### 3.4 Water Level (Flood) Design

The information in this section of the reference ABWR DCD, including all subsections and tables and figures, is incorporated by reference with the following supplements and departures.

Figure 3.4-1 Non-Breaking Wave Force on Vertical Wall

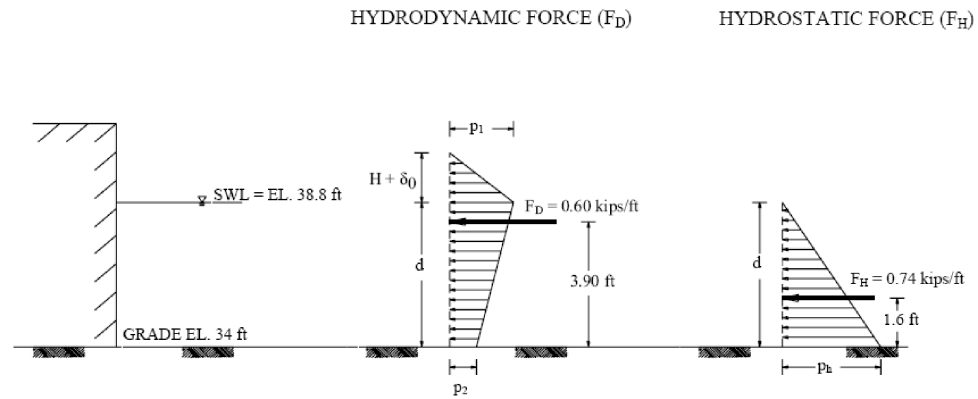
As discussed in Section 2.4S.4.2.2.4.3, the hydrodynamic force due to the wind-generated wave action on building walls has been calculated as shown in Figure 3.4-1.

- Wind generated wave forces as shown in Figure 3.4-1, applicable to above grade portion.
  - Impact due to a 500 lbs floating debris traveling at 4.72 ft/sec.

FL = Design basis extreme flood loads, including the hydrostatic load due to flood elevation at 40 ft MSL, the associated drag effects of 44 psf, impact due to floating debris per Section 3.4.2, and hydrodynamic load due to wind-generated wave action per Figure 3.4-1. Figure 3.4-1 shall only be used to calculate hydrodynamic load due to wind-generated wave action. The weight of the water (above ground) due to the flood loads shall be 63.85 pcf in order to include the effects of suspended sediments in the water.
